Reply to Reviewer 1

In this paper, the authors parameterize a sustained component of Non-Photochemical Quenching for boreal evergreen conifer forests within the QUINCY terrestrial biosphere model (TBM), in the view of improving the representation of leaf-level SIF emission. They implement and evaluate 3 modelling approaches to upscale leaf-level SIF fluxes to the canopy scale. Top-of-canopy (TOC) SIF and GPP simulations are compared at three sites against corresponding in situ estimates, as well as, for SIF, coarse spatial resolution space-borne SIF retrievals from TROPOMI at two sites.

Fig. R1. As Fig. 8 in the manuscript, except that the TROPOSIF is not for the 0.5 degrees x 0.5 degrees area around the site, but instead the observations are within the observed pixel.

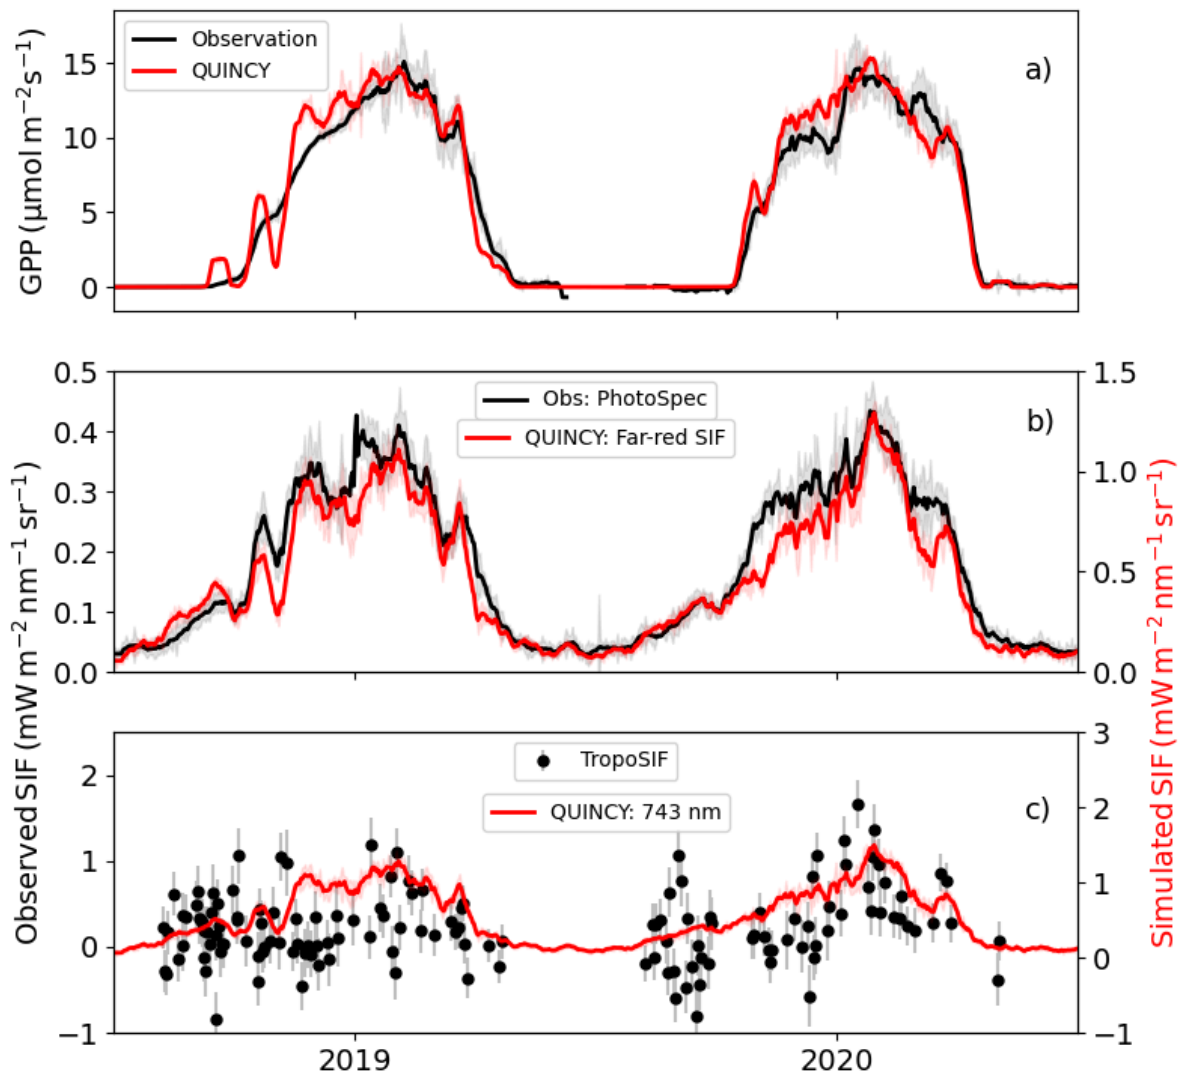
What puzzles me, is the spatial scale of 0.5° around the sites that is considered for averaging the satellite data, given the heterogeneity around the flux tower sites. For instance, CA-Obs (analyzed in Figure 8) is surrounded by lakes, with a "big" one about 6 km away from the site. To which extent surfaces different from "boreal evergreen coniferous forests" within the considered satellite footprints can contribute to the averaged values used for model evaluation? Why not considering an averaging at a higher spatial resolution?

As mentioned in the manuscript the pixel for the TROPOMI instrument is $3.5 \times 5.5 \text{ km}^2$. It is therefore very difficult to remove the influence of these lakes, as they can likely be inside the pixel. One can perhaps assume that most of the variation seen in the seasonal cycle of TROPOMI-observed SIF stems from the vegetation.

Averaging at 0.5° around the sites allows having enough observations so that the influence of random errors is not large and also ensuring that there will be enough observations. To address the concern by the reviewer, we calculated how much of evergreen needleleaf forests were included in the TROPISIF observations (based on MODIS land cover classification). This was 26 % for the CA-Obs site. 65 % of the region was classified as "woody savannah", which has 30-60% of tree cover. We will add this in the text and also the corresponding numbers for the FI-Sod site.
